Revised Wetland Restoration & Replication Plan

October 9, 2013

Numbers Highlighted in yellow will change as a result of reduced permanent wetland impacts. These changes will be made once the surveyor has drafted the plan changes and calculated the reduced impacts. In the interim attached are hand sketches of the plan changes.

**WETLAND RESTORATION AND REPLACEMENT PLAN
41 ESTERBROOK ROAD
ACTON, MA**

Wetland Restoration & Mitigation Plans

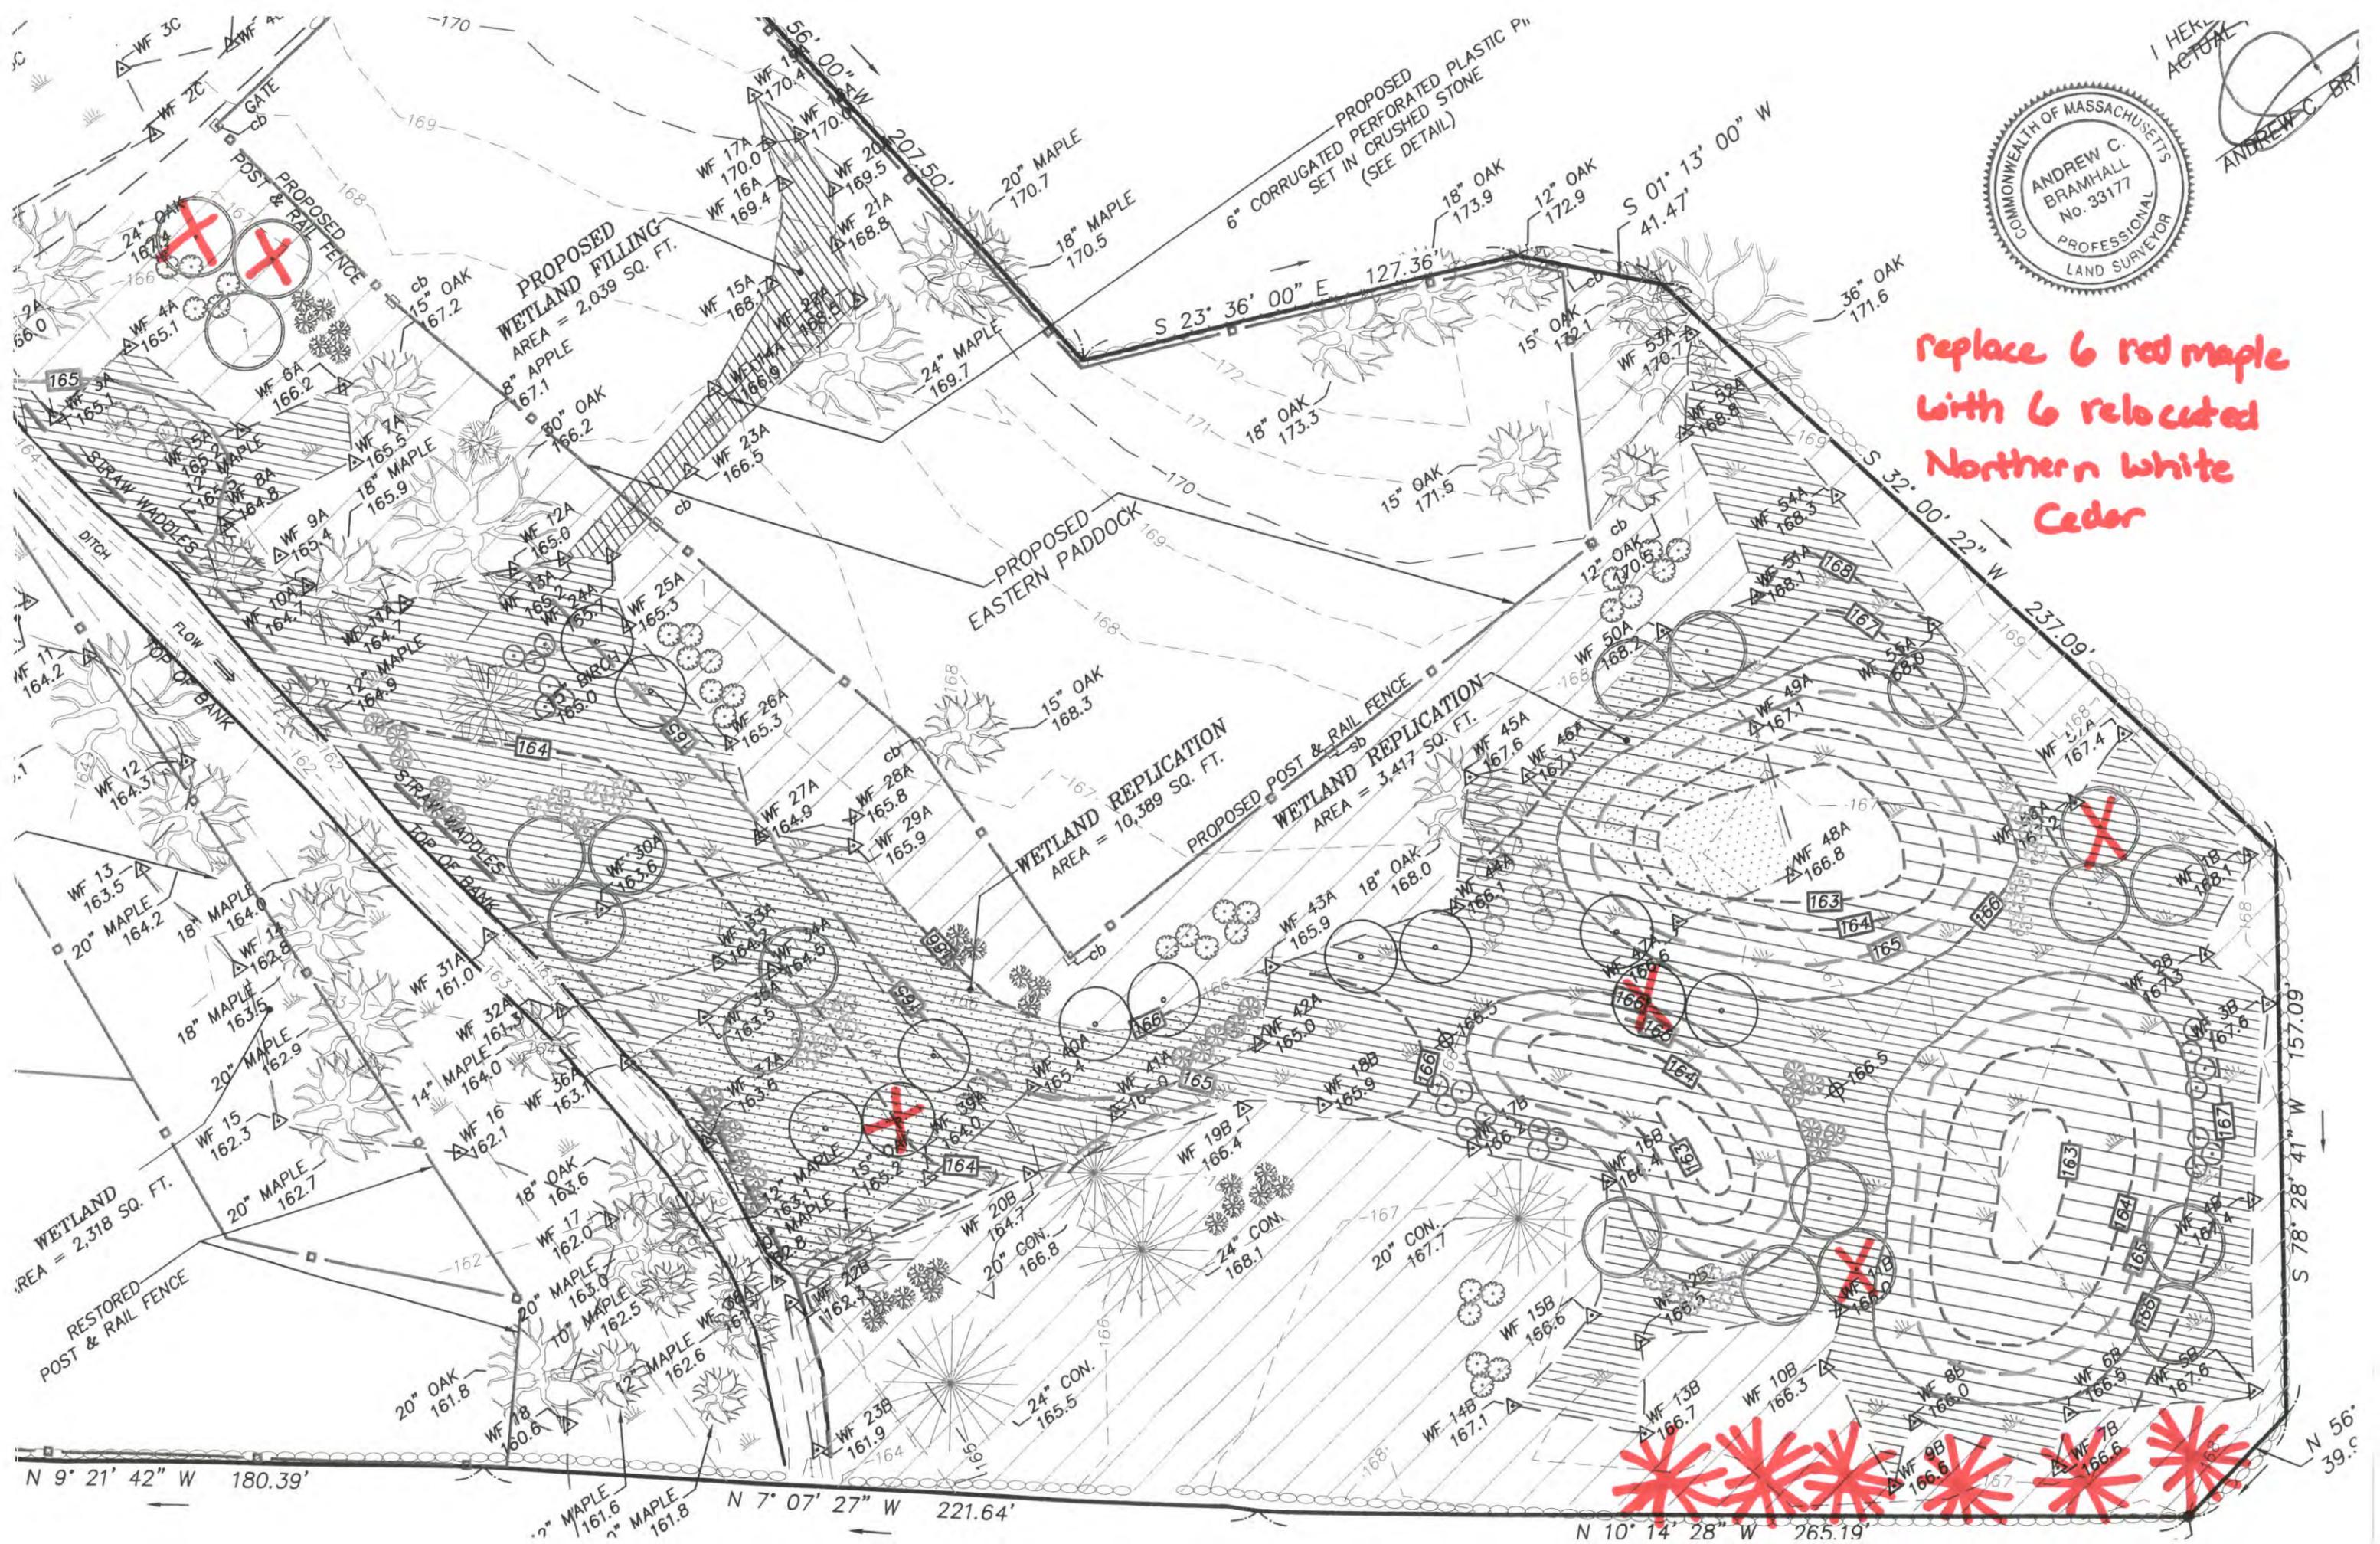
replace 6 red maple
with 6 relocated
Northern White
Cedar

"Concord Blend" Grass Mix for East Paddock.

- All plantings shall be native varieties with no landscape cultivars proposed ^{without prior} authorization from the Conservation Director.
- Specific placement of shrubs within the planting area ^S are approximate and will be established in the field by the Wetland Scientist. _{approved}
- Application of a thin coating of weed free straw mulch is recommended immediately following initial installation of seedmix for stabilization and protection as determined in the field by the Wetland Scientist. _{approved}
- If necessary, any required substitute native shrubs shall be reviewed with the Conservation Director prior to installation.
- The Wetland Restoration and Replication Areas are to be established following the Construction Sequence contained in the Wetland Restoration & Mitigation Plan and under the direct supervision of a ~~qualified~~ _{the approved} Wetland Scientist.
